FOUNDATION INVESTIGATION REPORT

W.P. 10-67-02

Muskrat River Bridge

Muskat River Bridge
W.P. 10-67-02, Site #29 - 158
Highway #17N, District 9, Ottawa

FIG No 4

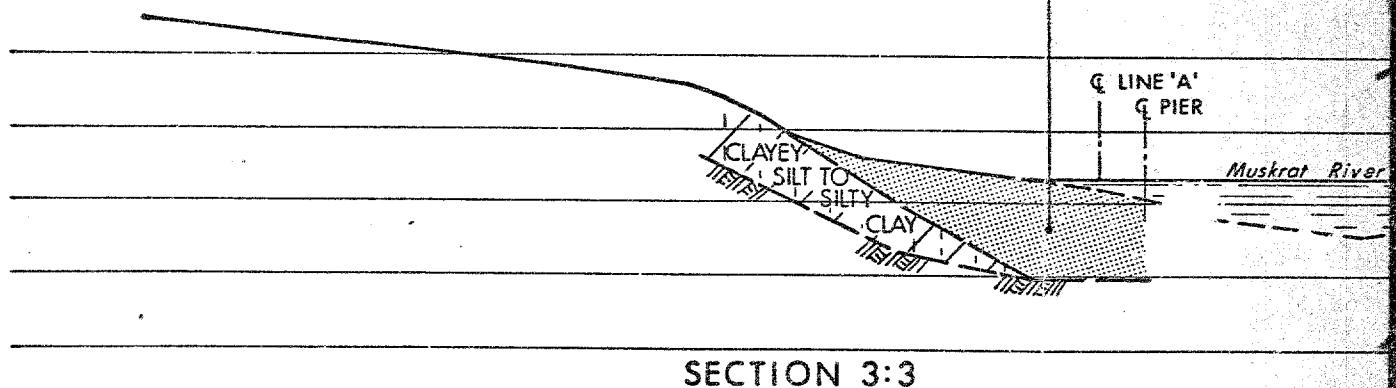
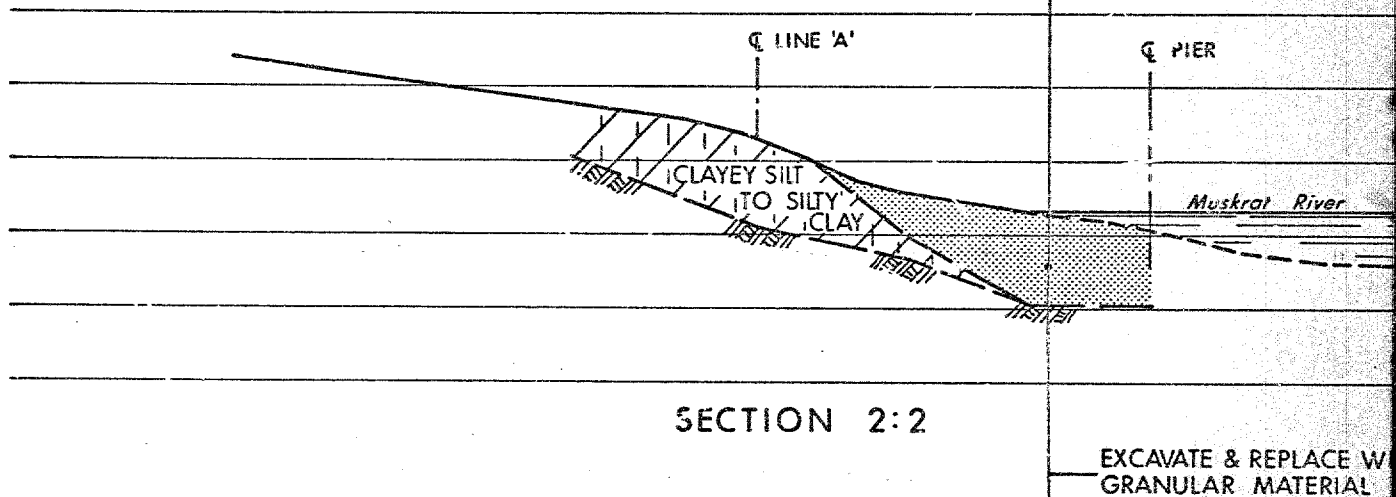
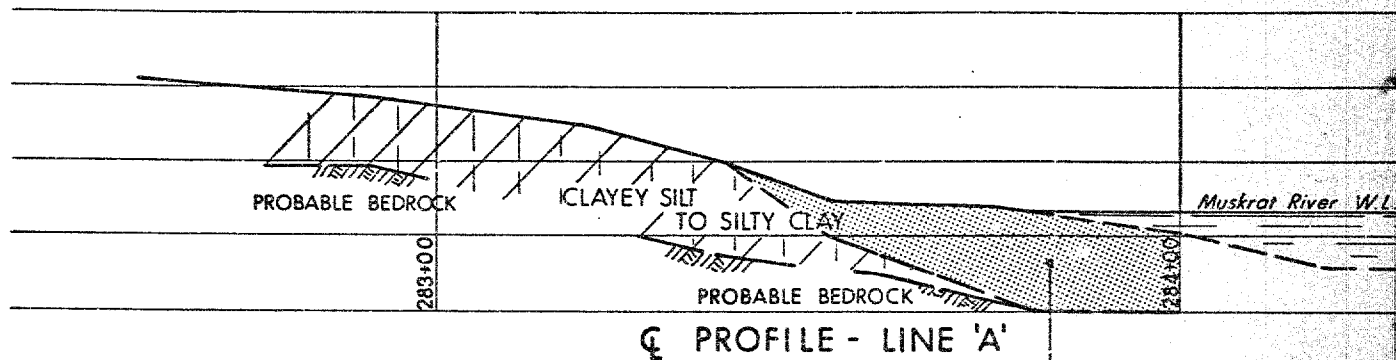
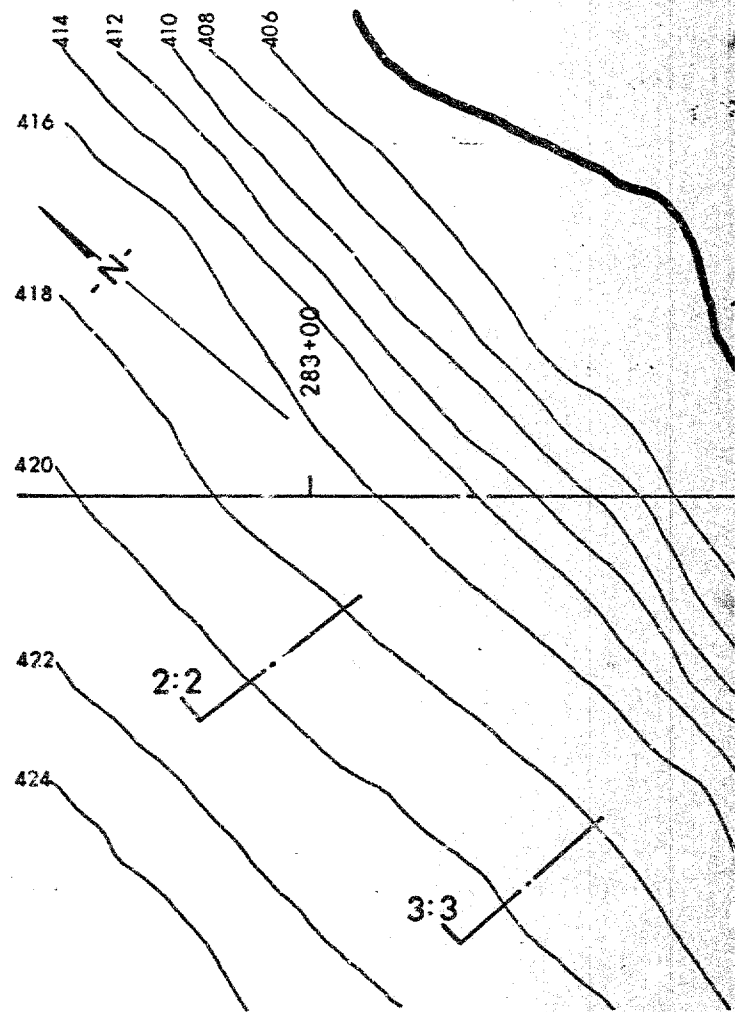
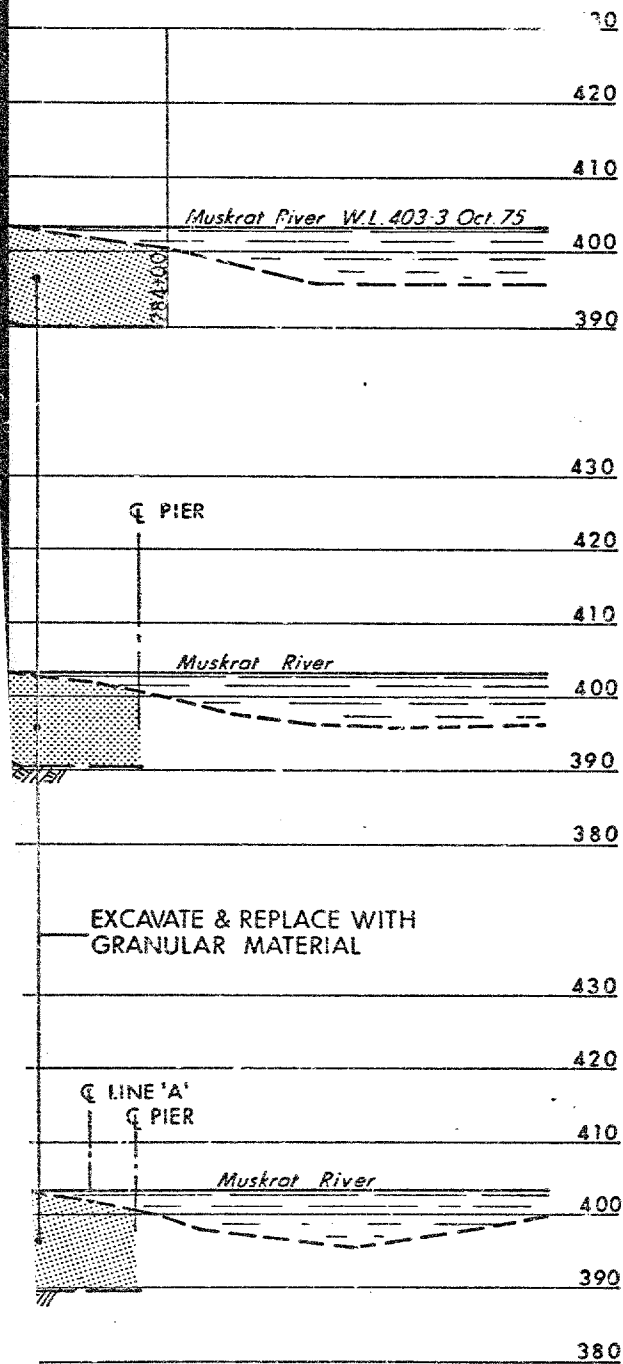
We have carried out a stability analysis for the east approach with the final grade lowered to elevation 420 as per your memorandum of April 23, 1976.

The analysis indicates that the forward slope as shown on Fig. No. 4 of the above report can be shifted towards the river parallel to itself along the centreline of the highway. The centreline of the highway should intersect the top of the new slope at Station 285+93 and the toe of the slope at Station 285+52 approximately. The new geometry will have a factor of safety of 1.09 along the most critical section, i.e., perpendicular to the river. In view of the low factor of safety it is recommended that additional rip rap be placed beyond the toe of the slope. Furthermore, the river should be partially filled where the slope comes very close to the river, as discussed with you on May 4, 1976.
